APS - 1269060

To: Rod Gerig  
From: Glenn Decker  
Subject: Double undulator small angle case tolerances  
Date: June 23, 2000

**Figure 1.** One mrad ID separation with 1 mrad distortion

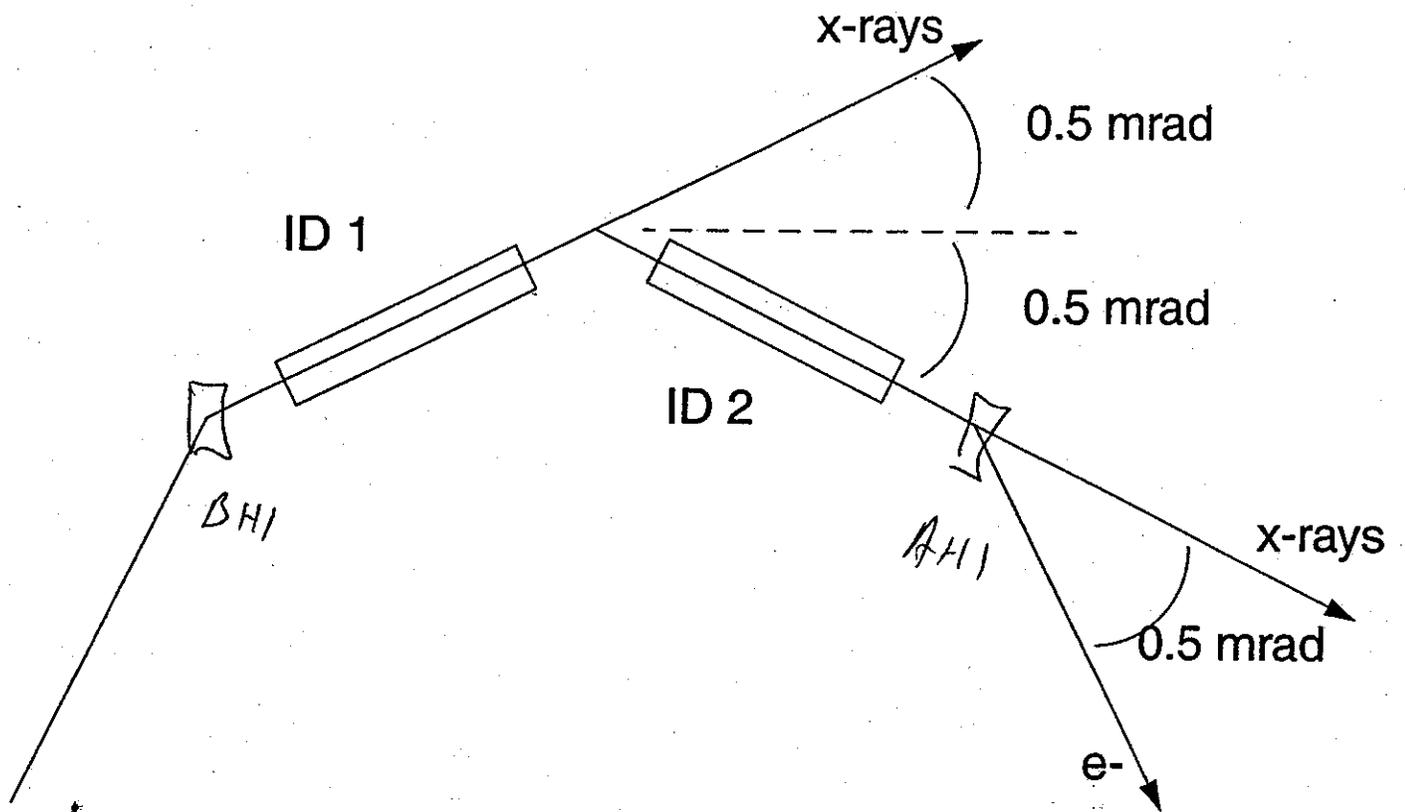
With regard to the so-called Decker distortion, keep in mind that only distortions greater than half the ID separation angle provide any benefit in the reduction of x-bpm backgrounds. For example, if we were to use the present 1.0 mrad distortion with a 1.0 mrad angle between ID's, the clearance between the nearest source of stray radiation and the ID beam would be only 0.5 mrad instead of the full 1.0 mrad for the single ID case. I expect that this should still provide adequate reduction in stray radiation backgrounds. The diagram shown in Figure 1 illustrates this situation.

In summary, while it is conceivable that a separation angle between insertion devices as large as 1.6 mrad could be made to work, it is my recommendation that this angle be kept to 1.0 mrad or lower. By doing so we will assure that no new issues arise from changing the parameters associated with either the beam position limits detector or the Decker distortion.
